Product Alert – Emerson Fisher Controls International LLC June 5th, 2023 DVC6215 Remote Feedback Assembly

Type of Notification: Safety Concern for Class I, Division 1, Group A Installation

IMPORTANT PRODUCT SERVICE NOTICE

DVC6215 units with nameplate drawing numbers GE68234 or GE91141 are impacted. The affected nameplates are shown on the next page with the drawing number locations highlighted red.

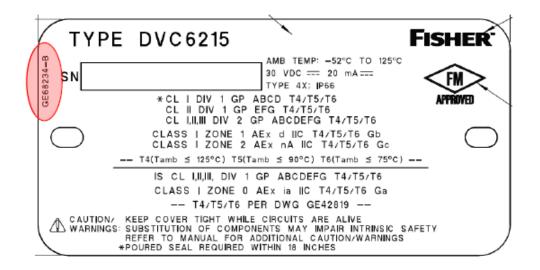
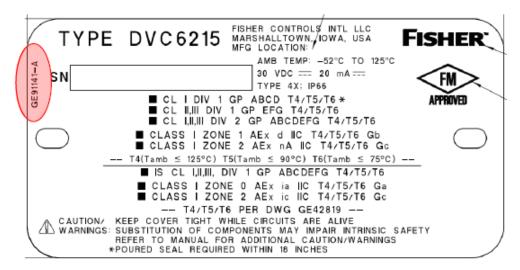
Hazard Involved: The manufactured product in question contains nameplate GE91141-A or GE68234-B (left side on nameplate) which has an incorrect statement "Poured Seal Required within 18 inches" which applies to the installation of the product. This statement on nameplates GE91141-A or GE68234-B is applicable for Class I, Division 1, Groups ABCD installations, whereas the correct nameplate will have the following statements.

Poured Seal Require Within:

- 18 inches for Class I, Division 1, Groups BCD for FM
- 2 inches for Class I, Division 1, Group A for FM

Poured seal within 18 inches in a Group A installation is a safety concern as Approval evaluation was not conducted with this criteria. Per the attached IMPORTANT PRODUCT SERVICE NOTICE, Fisher Controls International LLC will provide a wire-on tag with the words "POURED SEAL REQUIRED WITHIN 2 INCHES FOR CL I DIV 1 GROUP A FOR FM". This tag is to be attached to the product via one of the available unused mounting bolt holes.

This notice only applies to the DVC6215 Remote Feedback Assembly (Remote Travel Sensor) that was FM Approved (labeled) during the timeframe from 2015 to 2023. The product label was missing the following information on its nameplate, "POURED SEAL REQUIRED WITHIN – 2 INCHES FOR CL I DIV1 GROUP A FOR FM". The DVC6215 Remote Feedback Assembly (Remote Travel Sensor) itself is not affected but rather the information needed for ensuring a proper and safe installation in gas group A was not provided.

If you have an FM Approved DVC6215 Remote Feedback Assembly (Remote Travel Sensor) with one of the nameplates identified above installed in a Class I Division 1 Gas Group A application (not intrinsically safe), please ensure that a poured seal is installed within the recommended 2 inches for this hazardous area application.

A wire-on tag is being provided (free of charge) with the words "POURED SEAL REQUIRED WITHIN – 2 INCHES FOR CL I DIV1 GROUP A FOR FM" that is to be attached to the product via one of the available or unused mounting bolt holes. This is to ensure that the necessary installation information is retained "with the product".
